CASE#: C15-2016-0095

4812 PRAIRIE DUNES DRIVE

Board of Adjustment General/Parking Variance Application

Master Comment Report

IMPERVIOUS COVER SURVEY

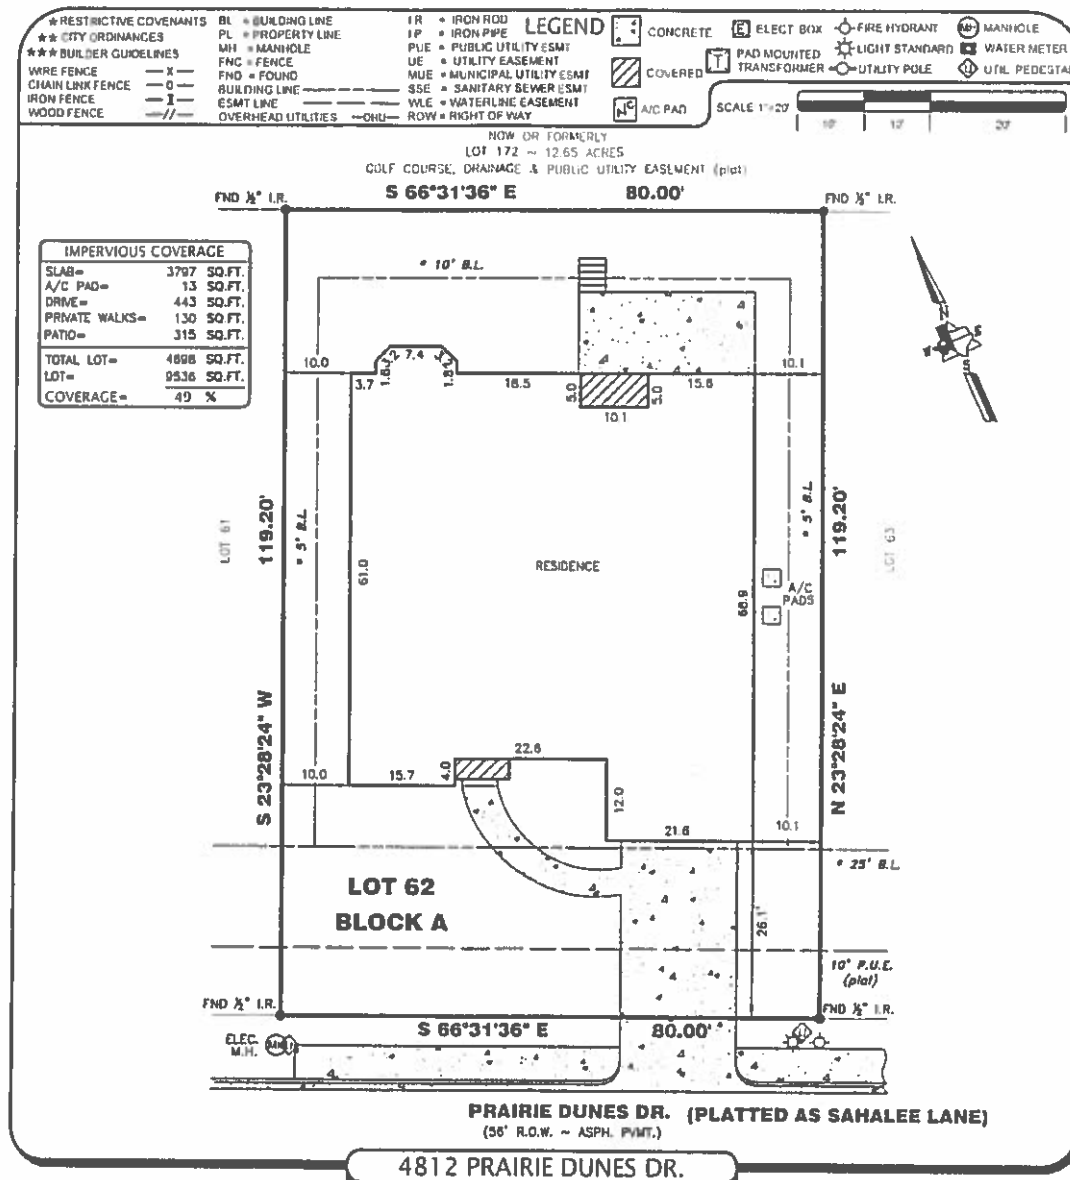
1. You are exceeding the maximum Impervious Cover allowed on the lot. Per lot size listed of 9,536 sq. ft x 45% = 4,291.2 sq. ft. You have 4,490 sq. ft. @ 47% on page 2 of Residential Application. You have two options:
 - a. Obtain an approved BOA Variance for the extra Impervious Cover through BOA Commission -P.O.C - Leane Heldenfels -located on 1st FL of the DAC (512) 974-2202, Customer Walk-in Hours 9a.m. - 12p.m. Monday - Friday, or leane.heldenfels@austintexas.gov

Please keep in mind your Maximum Building Coverage is 40%, -per Residential Applic. lot size is 9,536 sq. ft. x 40% = 3,814.4 sq. ft. max, your Maximum Impervious Coverage is 45%, per application lot size is 9,536 sq. ft. x 45% = 4,291.2 sq. ft. max ; You CANNOT exceed the maximum allowed for B.C or I.C

Impervious survey (attached) reveals 49.27% impervious cover now. By removing the existing concrete deck (320 sq. feet) and replacing with a pool (only coping counts against impervious cover) with an attached composite deck (50% of deck area), we can install the pool and deck and actually reduce our impervious cover to 49.21%.

APPROVED BY
AUSTIN ENERGY
FOR BOA

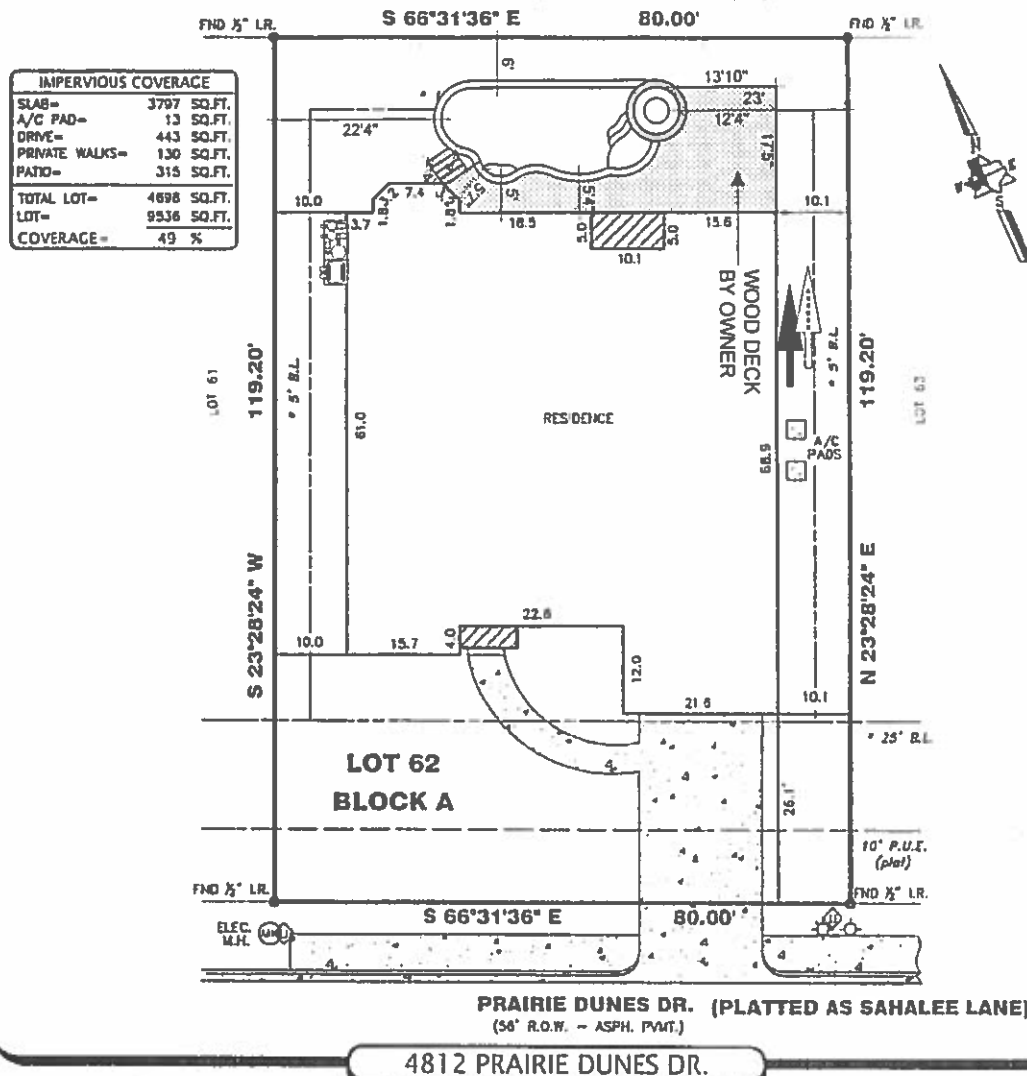
Austin Energy does not oppose your application for the requested variances, which is shown on the attached electronic stamped sketch, provided that any proposed and existing improvements are in compliance with Austin Energy clearance criteria requirements, the National Electric Safety Code and OSHA. Any removal or relocation of existing electric facilities will be at owners/applicants expense.
